### Change Order - Construction Manager-Adviser Edition

PROJECT (Name and address):	CHANGE ORDER NUMBER: 027		OWNER: 🛛
East Hardin Middle School Elizabethtown, KY	INITIATION DATE: March 29, 2021	CONSTRU	CTION MANAGER: 🖂
			ARCHITECT:
TO CONTRACTOR (Name and address):	PROJECT NUMBERS: BG 18-267 / 201752-01		CONTRACTOR:
Edgar Belle LLC 583 Ballard Lane	CONTRACT DATE: April 18, 2019 CONTRACT FOR: BP 030-04 General Trades		FIELD: 🛛
New Haven, KY 40051	CONTRACT FOR DE 050-04 General Haues		KDE: ⊠
THE CONTRACT IS CHANGED AS FOLLOW	vs:		
Costs associated with adding expansi	on joint covers to selected areas.		
The original Contract Sum was	7.00 (C)	\$	1,207,748.71
Net change by previously authorized Cha	nge Orders	51	8,893.90
The Contract Sum prior to this Change O	rder was	\$ _	1,216,642.61
The Contract Sum will be increased by th	is Change Order in the amount of	\$ _	9,368.93
The new Contract Sum including this Cha	ange Order will be	\$ <sup>-</sup>	1,226,011.54

### EAST HARDIN MIDDLE SCHOOL PROPOSAL REQUEST PRICING SHEET

PROPOSED CHANGE RE	QUEST NO.	<u>N/A</u>	DATE	<u>2/25/2021</u>		
DESCRIPTION	Expansion	Joint Covers - SEE AT	TACHMENT F	OR AREAS I	NCLUDED	
CONTRACTOR	EdgarBelle	Con

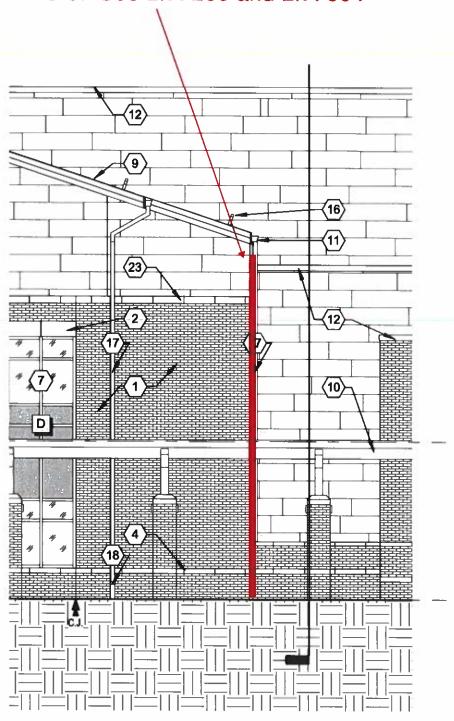
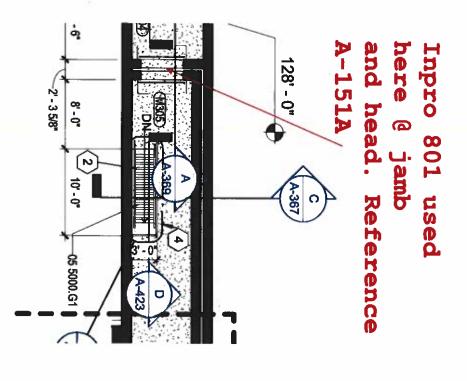
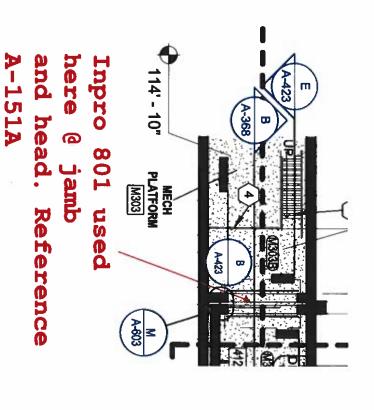
### Inpro 1200 Expansion Joint used here. See B/A-203 and B/A-504
